**S E R V I C E N O T E**

**E8356A PNA Microwave Network Analyzers**

**Serial Numbers: US00000000/US99999999 and MY00000000/MY00000000 [All]**

**A connector of the ribbon cable (Agilent part number 8120-8409) that joins the front panel display to the front panel interface board can loosen, causing a display failure, unless a new bracket is installed. Because the failure rate has been very low, *it is recommended that the bracket be installed only when there is an additional reason to remove the PNA front panel.***

**Figure 1:** A3 Front Panel Interface Board Assy without the Bracket

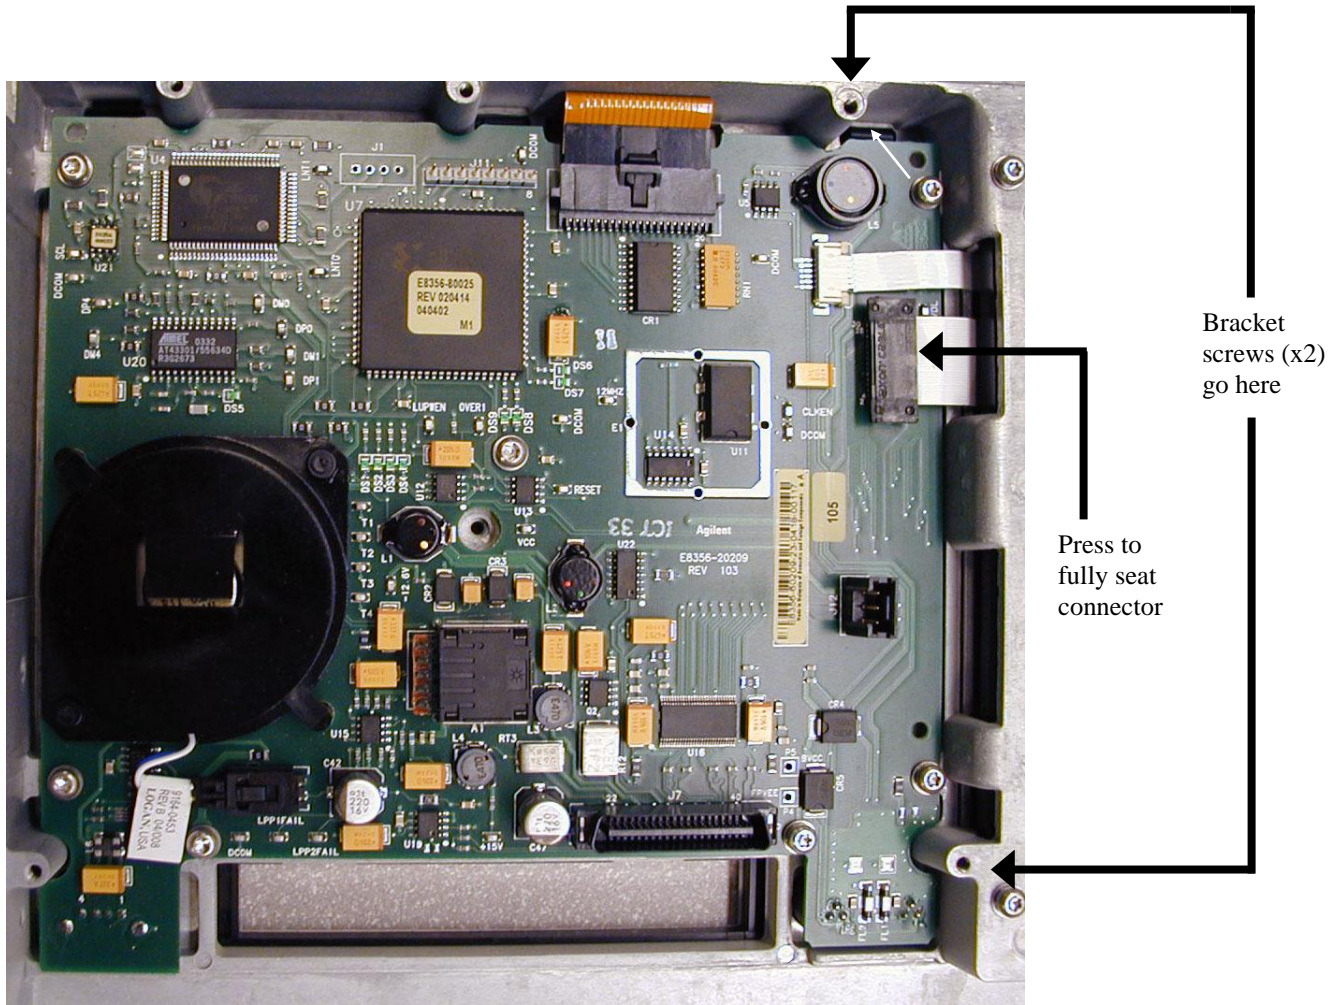
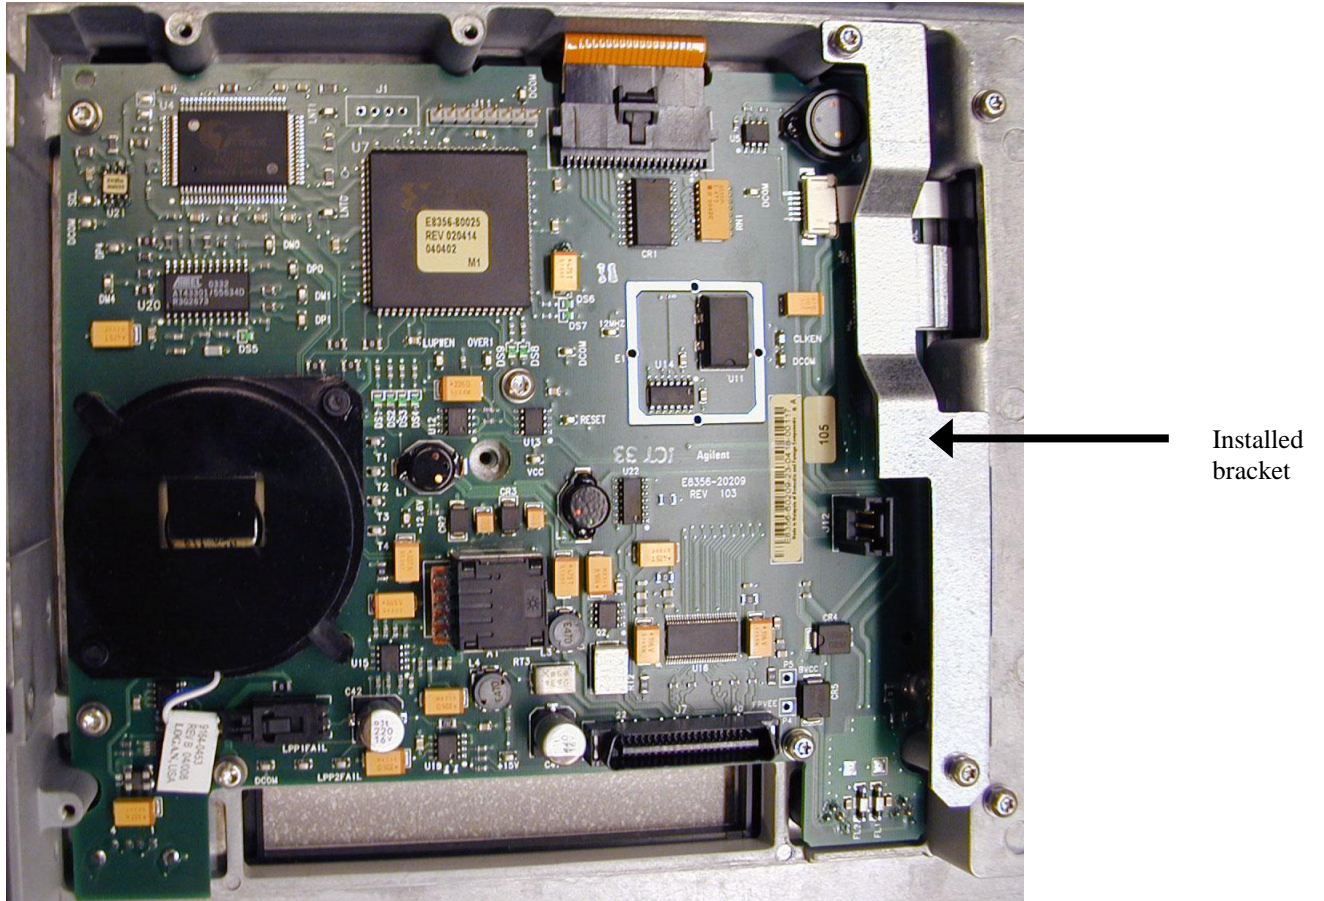
A connector of the ribbon cable (Agilent part number 8120-8409) that joins the front panel display to the front panel interface board can loosen, causing a display failure, unless a new bracket is installed. Because the failure rate has been very low, it is recommended that the bracket be installed only when there is an additional reason to remove the PNA front panel.

1. Refer to Figure 1 in this document:
  - Press down firmly on the ribbon cable's black connector.
  - Locate the two tapped holes for the bracket screws.
2. As shown in Figure 2 in this document, position the bracket so that its holes line-up with the two holes you located in the previous step.
3. Hand-start the two screws, and then torque both to 9 in-lbs.
4. Reinstall the PNA Front Panel by following the Service Guide instructions in the "Replacement Procedure." This is located on the same page as the "Removal Procedure" used previously in step 7.
